SUMMARY MEETING NOTES OF NRC BWIP HYDROLOGY REVIEW TEAM MEETING
NOVEMBER 6-7, 1986

Re: NWC Re-Review of Clifton's BWIP GWTT Analysis

REPORT TO
NUCLEAR REGULATORY COMMISSION
ON
RE-REVIEW OF CLIFTON'S
GROUNDWATER TRAVEL TIME EVALUATION

Figure 1 - Distributions of Flow Top Transmissivities

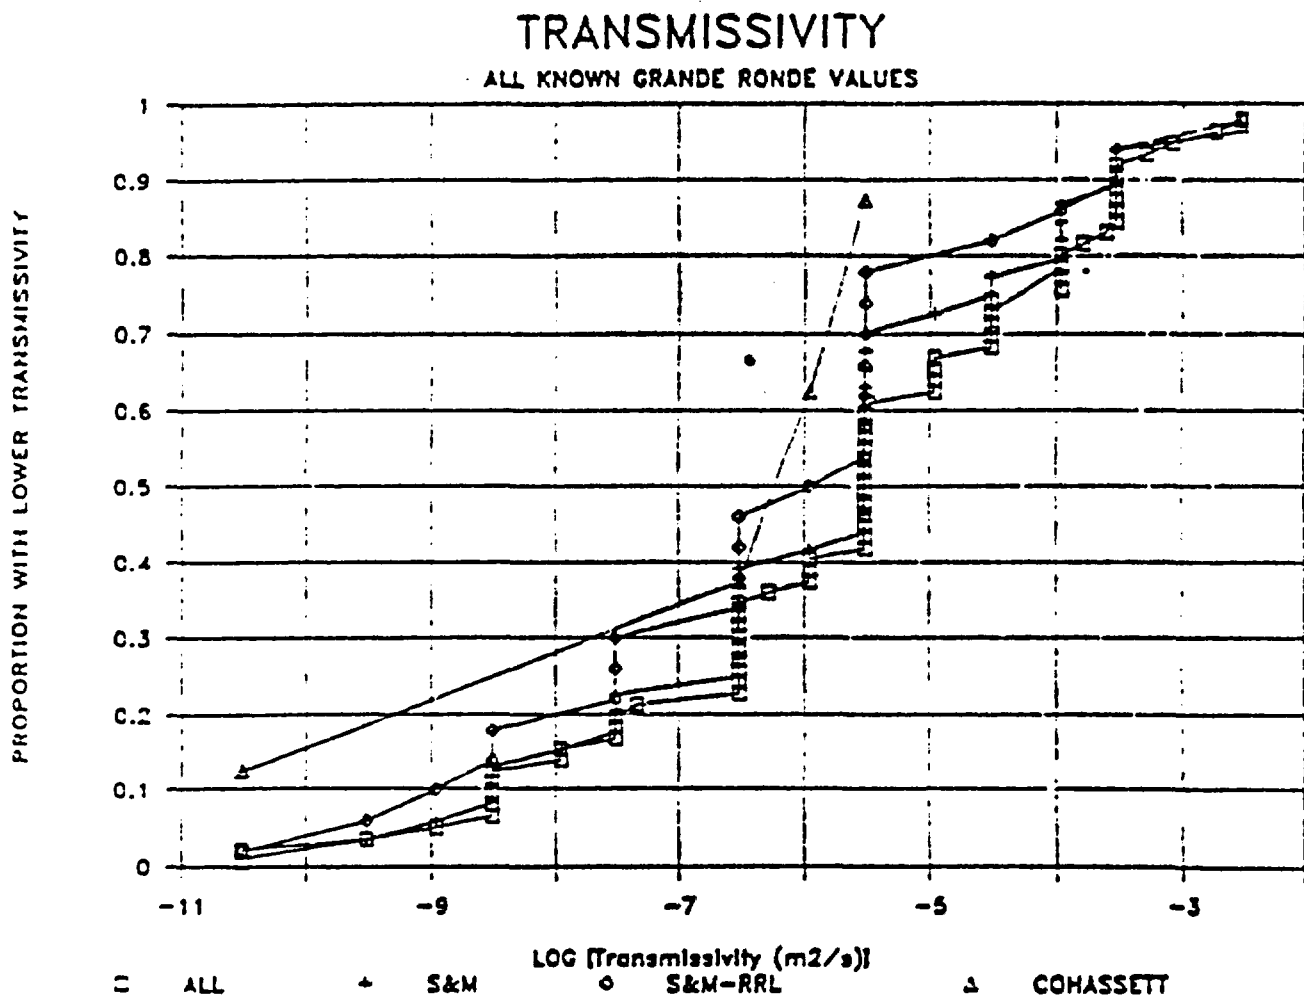
The results collected by NWC are indicated in Table 1. This information has been taken from the NWC database, which is described in (TTI, 1986). Of the 64 different values in the database, 45 (70%) are taken from Strait and Mercer (1986), 28 (44%) are from relatively close to the RRL (i.e. excluding DC-14 and DC-15 as was done by Clifton), and 5 (8%) are from the Cohasset flow top relatively close to the RRL. The relationship between the distributions of the values is of considerable concern. The cumulative distributions (made symmetrical for plotting purposes) are presented in Figure 1. Inspection of these curves indicates that the overall data appears to be approximately

log-normal. Further, the distributions of the overall database, the portion taken from Strait and Mercer (1985), and the portion of the Strait and Mercer (1986) data that are also relatively close to the RRL are all approximately the same distributions. The four values from the Conassett Flow top, which is the flow top that Clifton wished to use in his analysis, but was prevented by the small number of samples, has a lower geometric mean transmissivity than the other three distributions.

Figure 2 - Relationship between Porosity and Hydraulic Conductivity

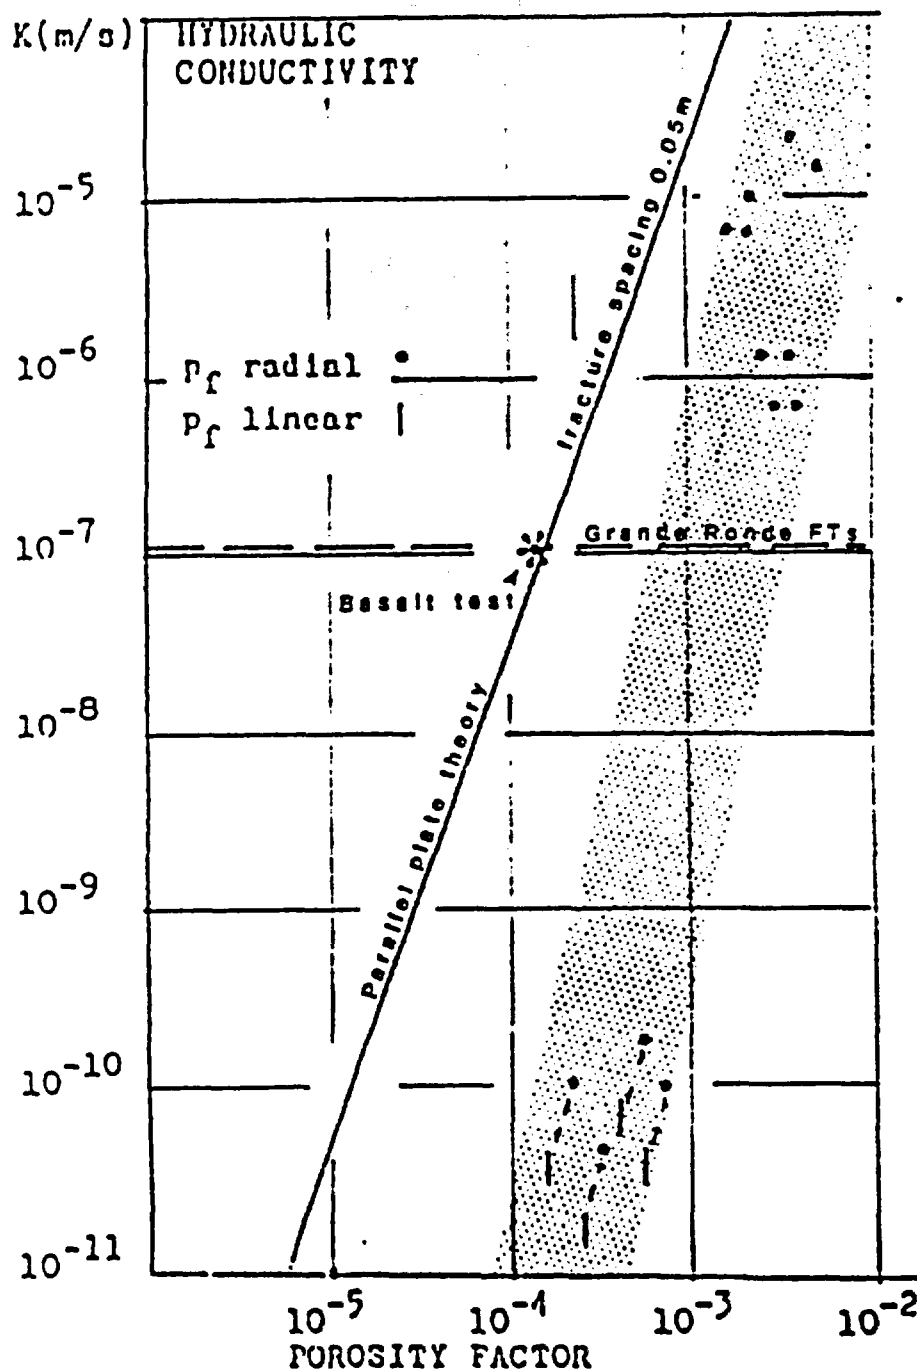
In addition, it has been hypothesized that the porosity and hydraulic conductivity of fractured rock are related (Snow, 1968; Sharp, 1970; Brezzen, 1985). If this is so, then the distributions of these parameters would be expected to be the same. As it is accepted that the distribution of hydraulic conductivity in fractured rock is log normal, it seems reasonable to assume that the distribution of effective porosity is also log normal.
